ADDENDUM NO. 1

RE: Item #3, February 17, 2016 Letting - IM 0901(162)14, P 014A(11)8, PCN 020U, 0217, Lawrence County - Reconstruct Interchange, Reconfigure Ramps, & Reconfigure Service Road

PLANS: Please destroy sheets A2, A3, A5, B2, B5, B6, B7, B9, B10, B43, B62, B63, B71, B72, C2, C5, C8, D7, E71, F2, F7, and L2 and replace with the enclosed sheets, dated 1/28/16, 1/29/16, 2/1/16, 2/2/16, 2/3/16. Sheet B15A was added.

Plotting Date: 2/1/2016
Revised Date: 1/29/2016 AMO

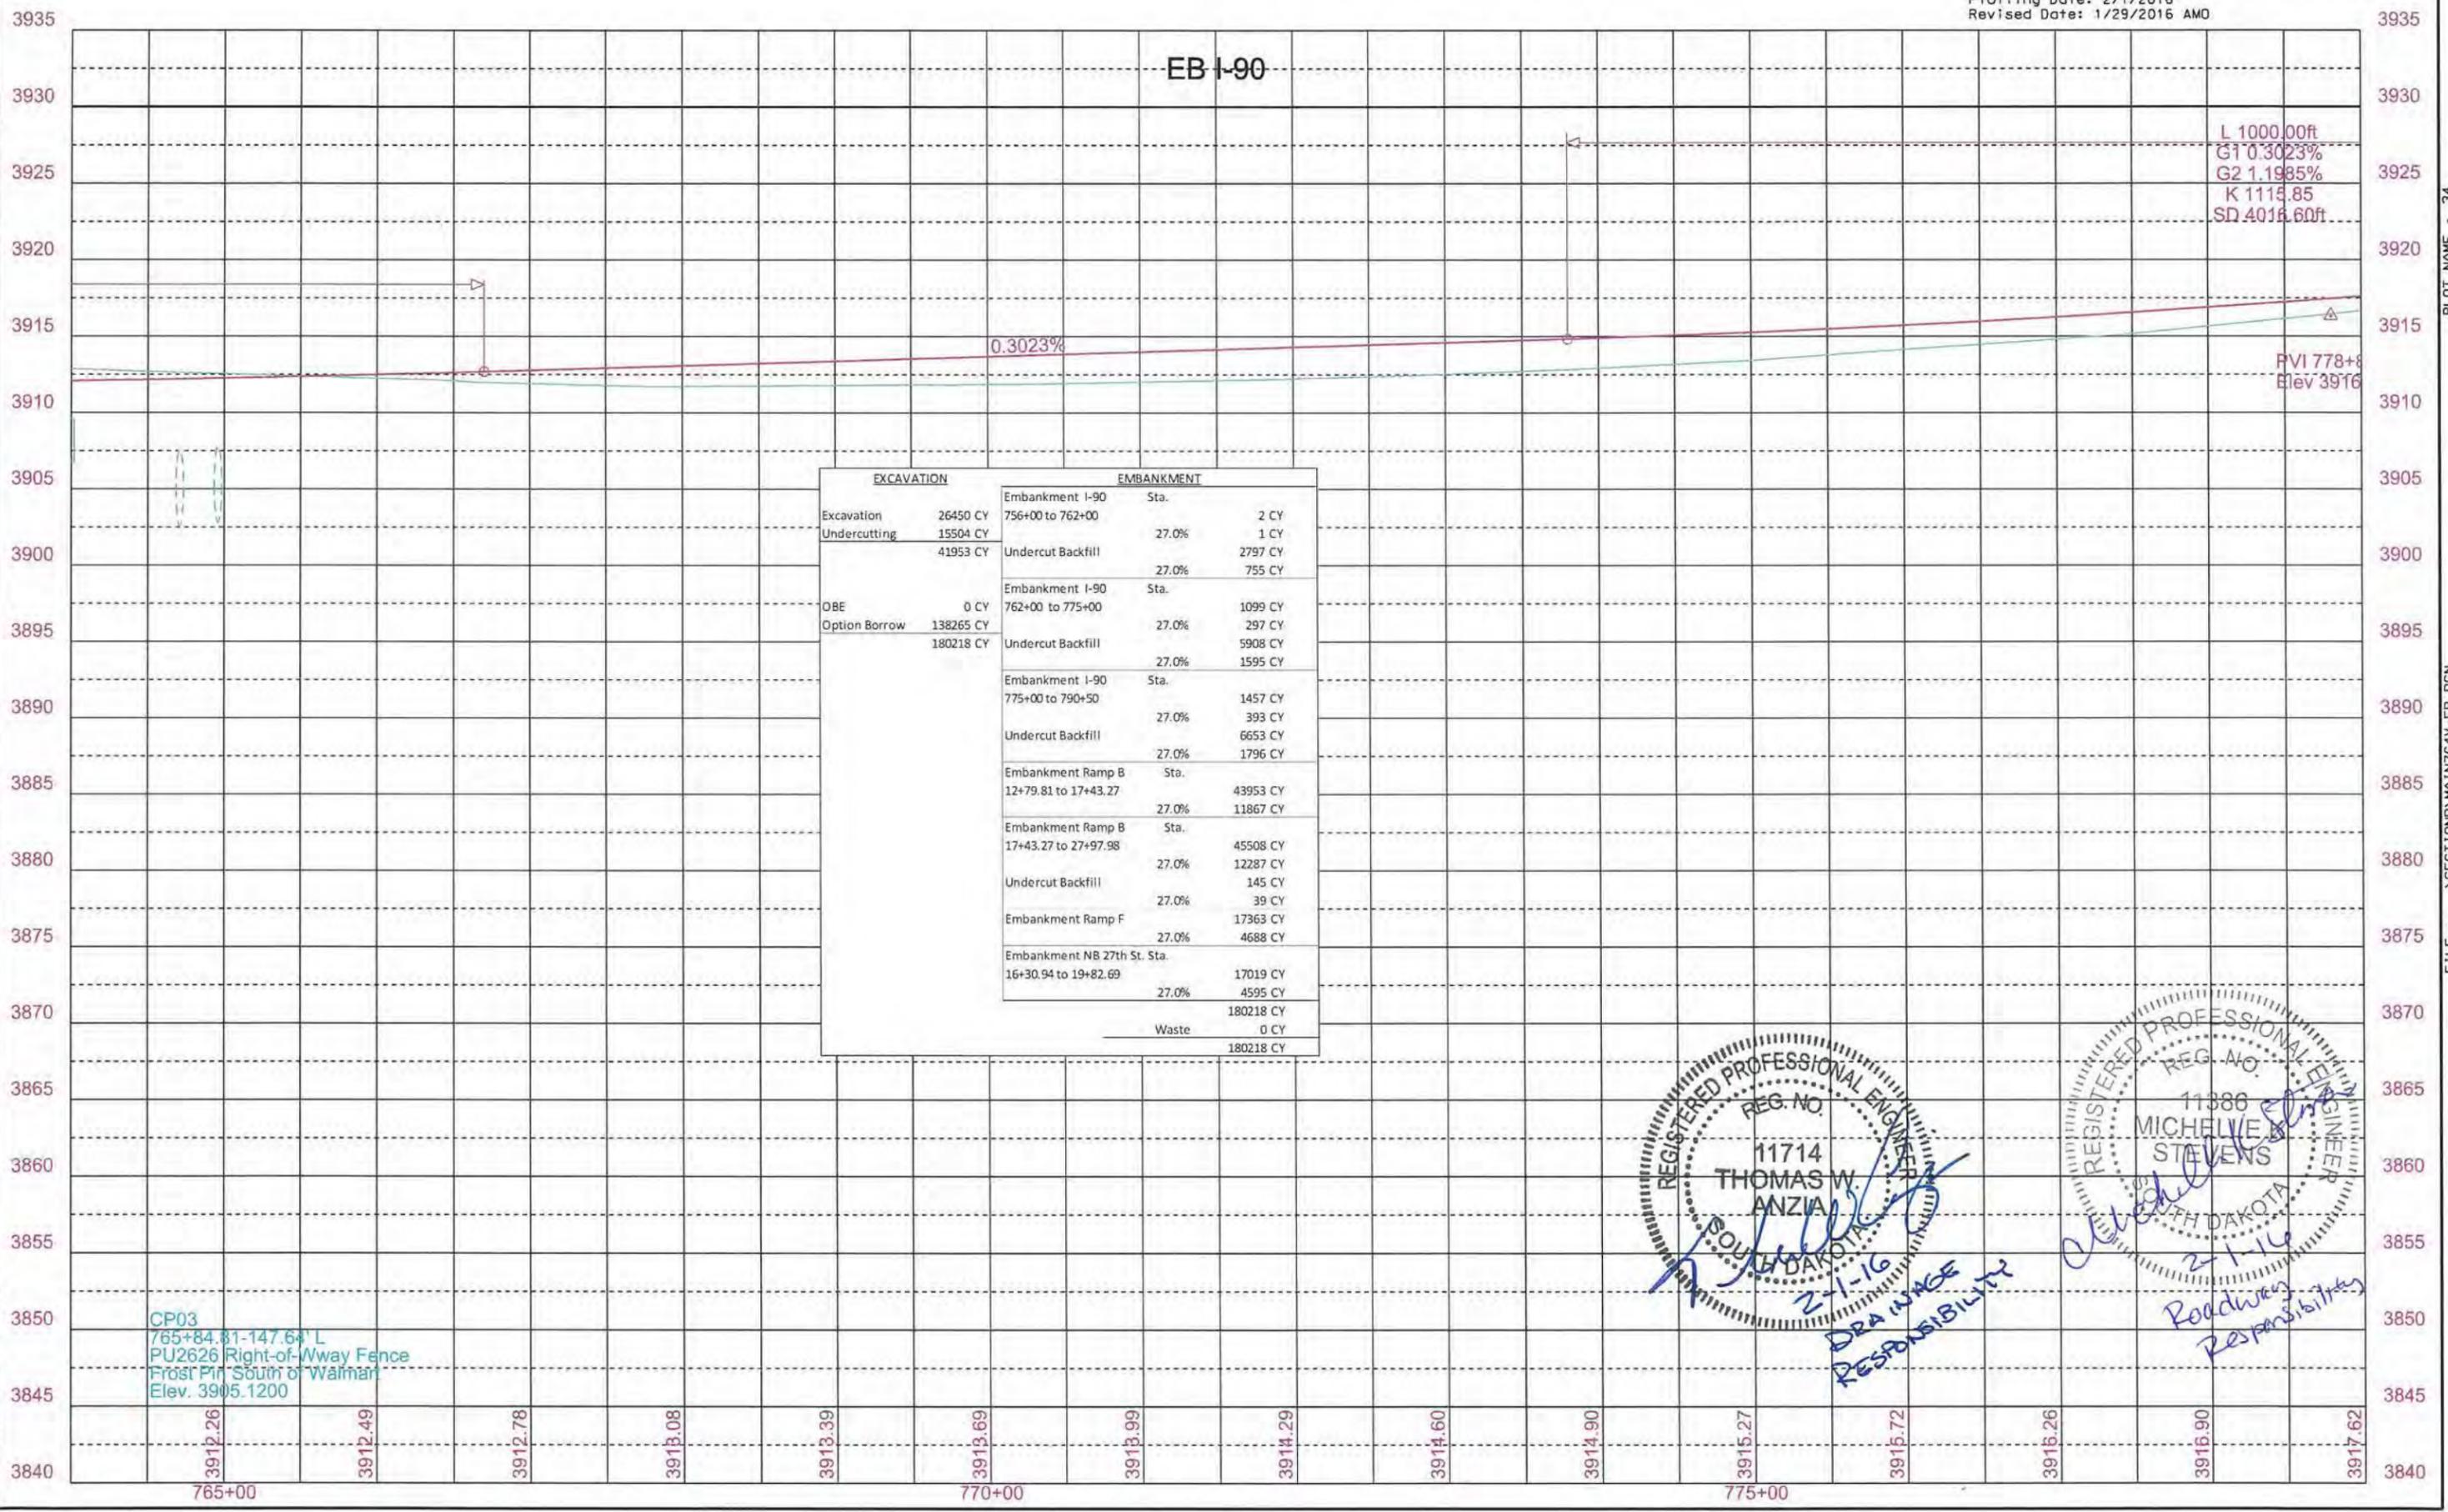
- Sheet B43:** Typical Section for Stationing for Undercutting was updated.
- Sheets B62, B63, B71 & B72:** Profile for Stationing for Undercutting was updated.
